Service Bulletin No: 24-002
Modification No: EC-12-0028

Ref No: 71
ATA Chapter: 24

ELECTRICAL POWER - GENERAL**DO AN INSPECTION AND ADD A PROTECTIVE SLEEVE TO THE LEFT AND RIGHT WIRE LOOMS IN THE FRONT COCKPIT ADJACENT TO FRAME 10****1. Planning Information****A. Effectivity**

Inspection / Modification (Left Side)
Figure 1

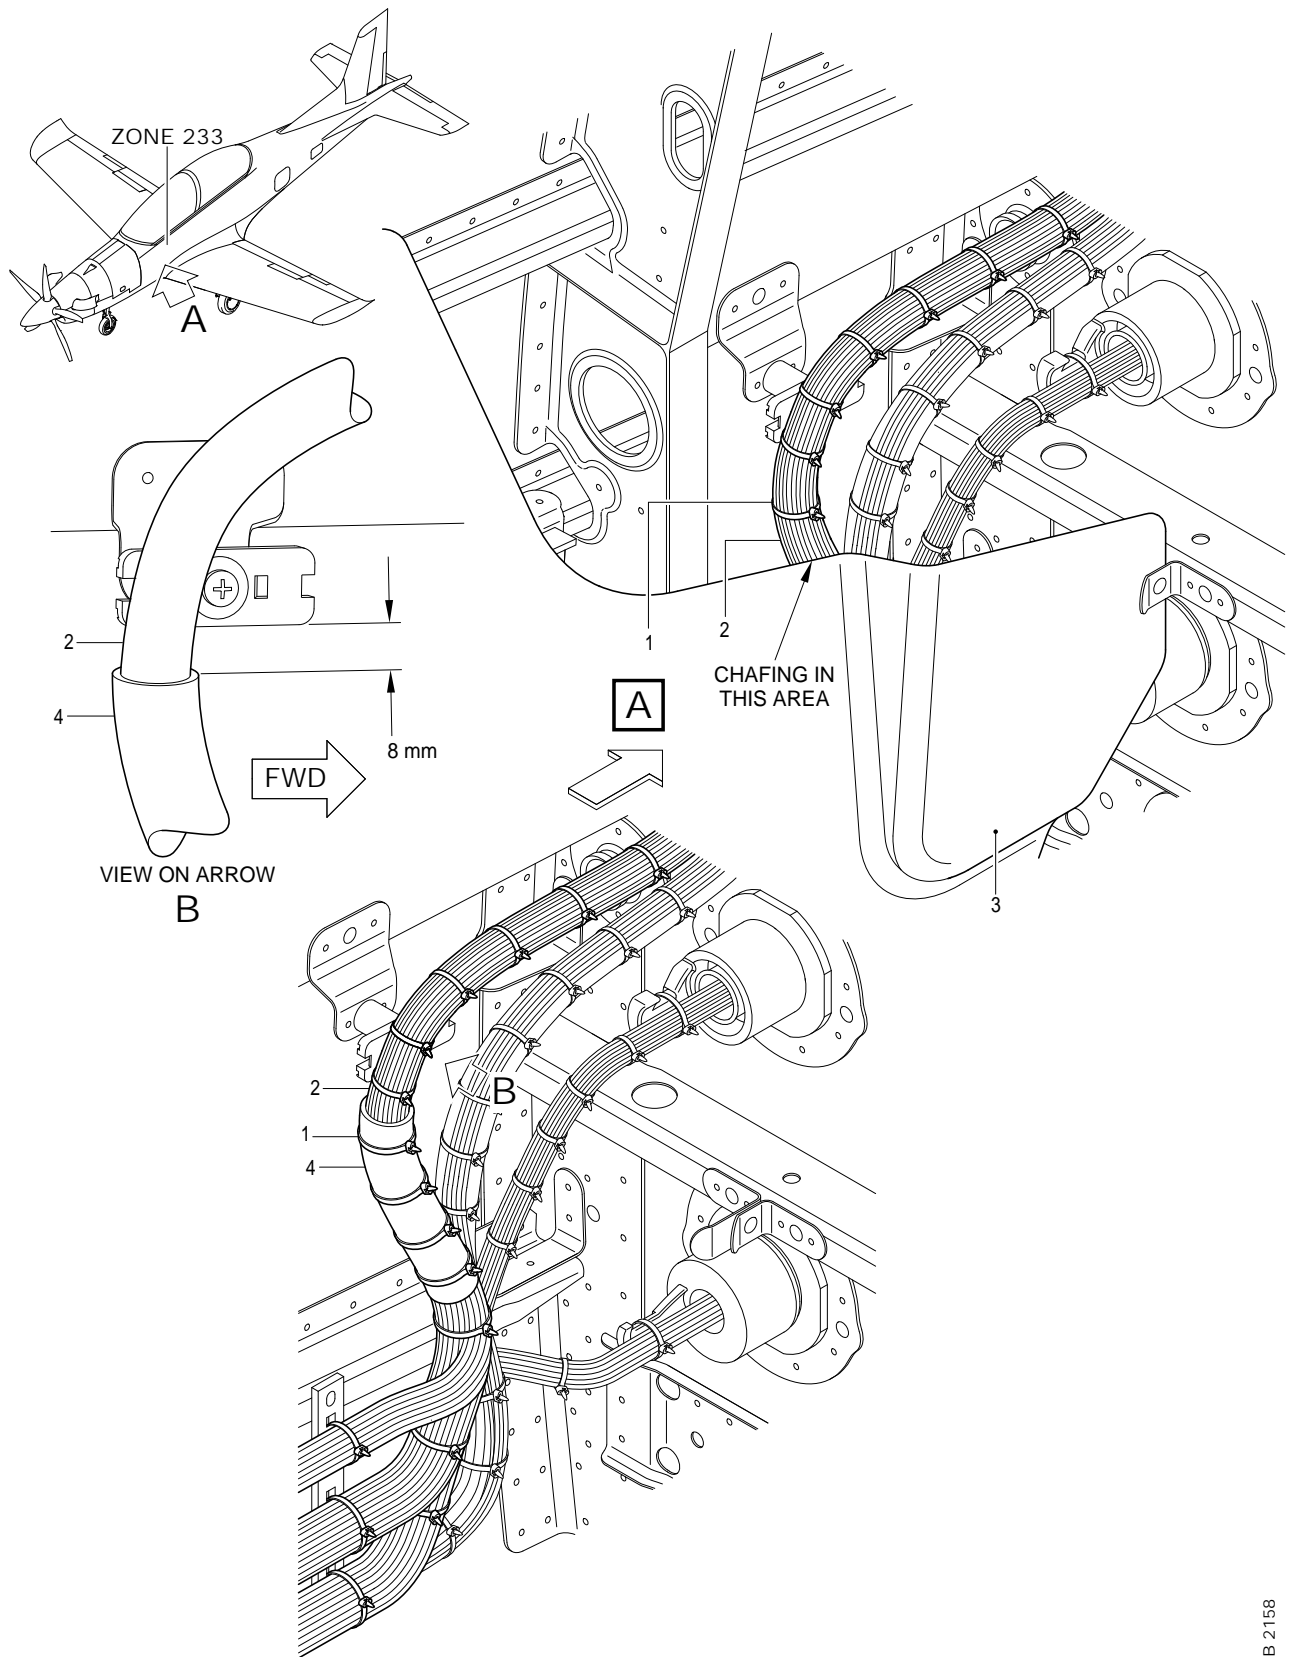
- (1) For the left side (Ref. Fig. 1)

- (a) Measure the clearance between the lower left forward panel (3) and the cable loom (2).
- (b) Tell Pilatus the actual clearance.
- (c) Remove the lower left forward panel (3).
- (d) Locate the cable loom (2) located adjacent to FR10 (Ref Detail A).
- (e) Remove the cable ties (1), as necessary, to free the wires in the affected area.
- (f) Inspect the wires on the outside of the loom (2) for signs of chafing.
- (g) Report all wires that show signs of chafing to Pilatus. If possible, give the wire number and the position of the chafing. Take photographs if possible. Wait for instructions from Pilatus before you return the aircraft to service.

- (1) For the left side (Ref. Fig. 1):
 - (a) Open the protection sleeve (4) (P/N 524.60.21.248) and put it in position around the cable loom (2) (Refer to Detail B). Make sure there are no cable ties beneath the protection sleeve (4) (P/N 524.60.21.248).
 - (b) Wrap the protection sleeve (4) (P/N 524.60.21.248) around the wires in the cable loom (2) and keep it in position with the cable ties (1) (Material No. P09-005, Material No. P09-008, and / or Material No. P09-014).
 - (c) Make sure the ends of the cable ties (1) (Material No. P09-005, Material No. P09-008, and / or Material No. P09-014) cannot cause damage to the adjacent wires and cables.

- (d) Install the lower left forward panel (3).
- (2) Do Paragraph 3.C.(1) to the right side (Ref. Fig. 2).

Inspection / Modification (Right Side)
Figure 2

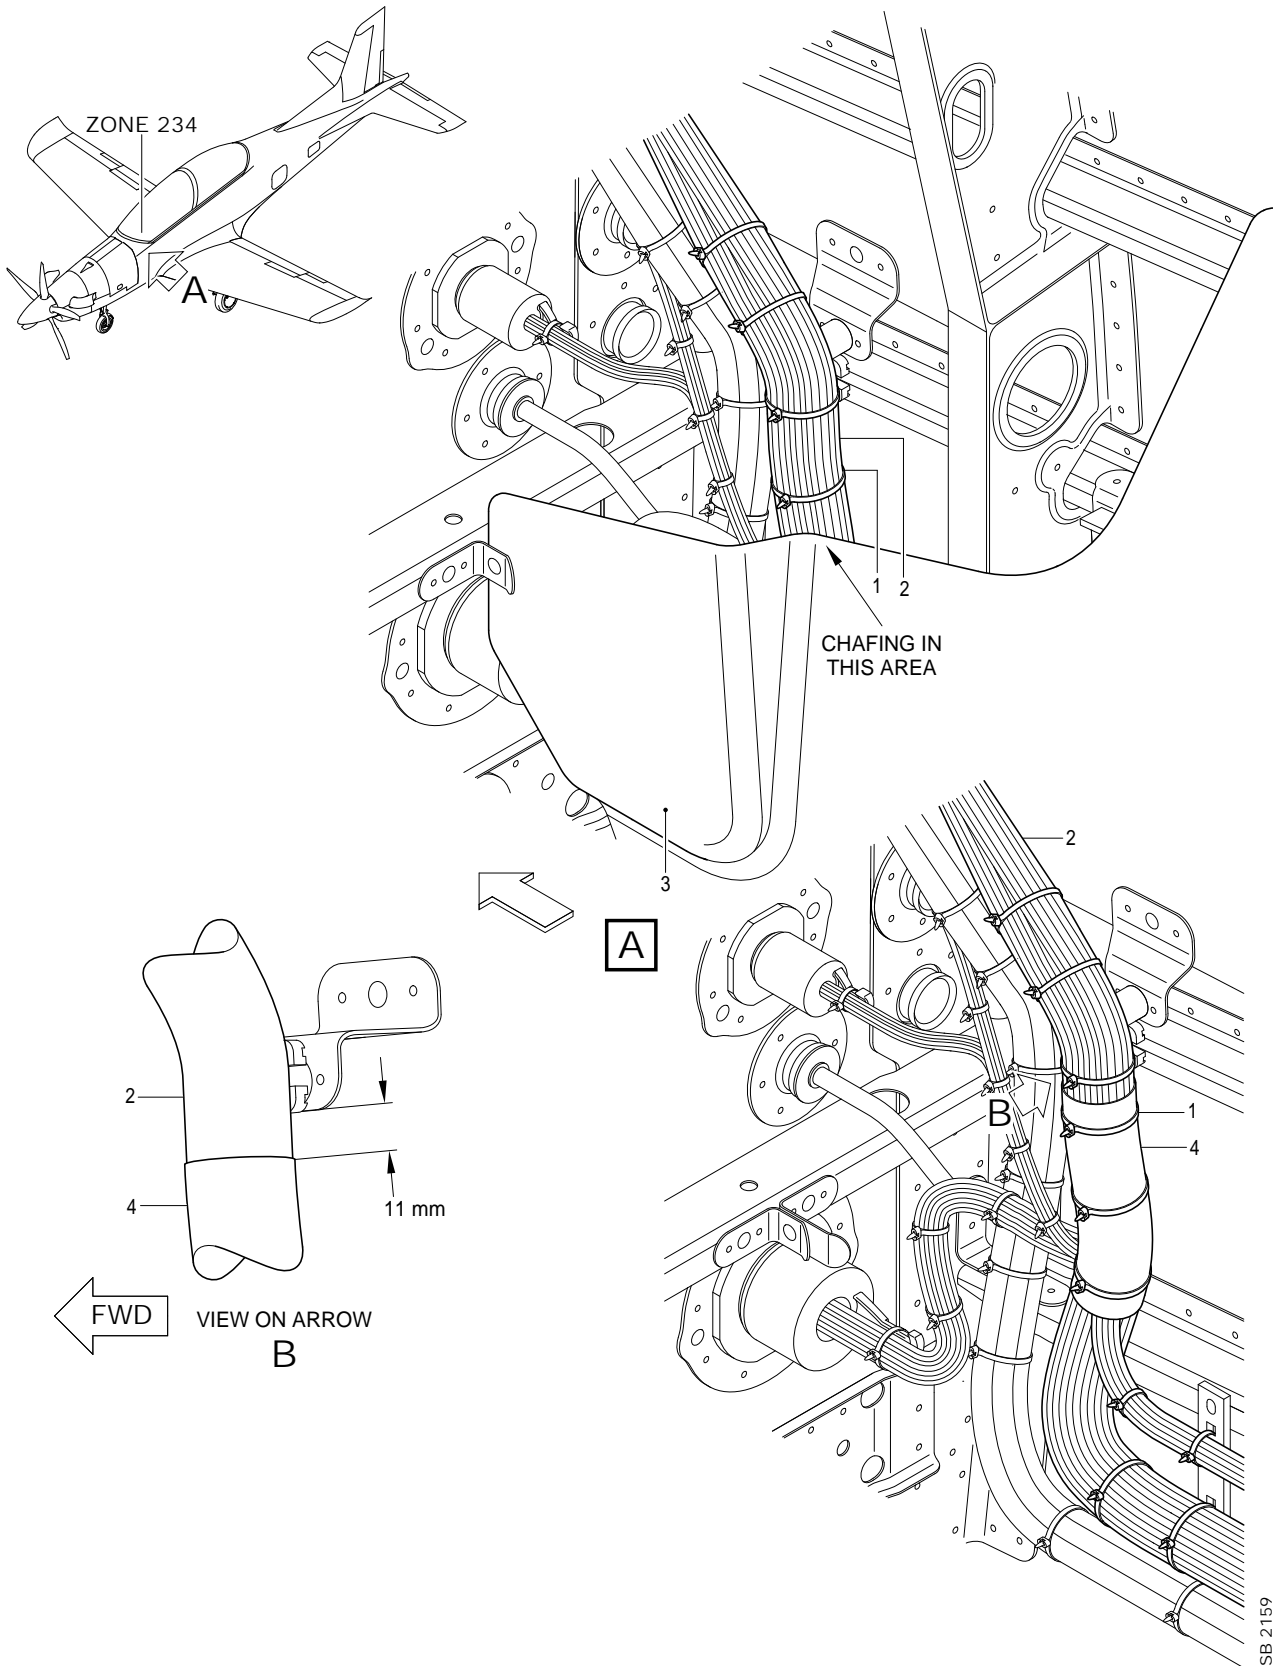
- (2) For the right side (Ref. Fig. 2)

- (a) Measure the clearance between the lower left forward panel (3) and the cable loom (2).
- (b) Tell Pilatus the actual clearance.

- (c) Remove the lower right forward panel (3).
- (d) Locate the cable looms (2) located adjacent to FR10 (Ref Detail A).
- (e) Remove the cable ties (1), as necessary, to free the wires in the affected area.
- (f) Inspect the wires on the outside of the loom (2) for signs of chafing.
- (g) Report all wires that show signs of chafing to Pilatus. If possible, give the wire number and the position of the chafing. Take photographs if possible. Wait for instructions from Pilatus before you return the aircraft to service.
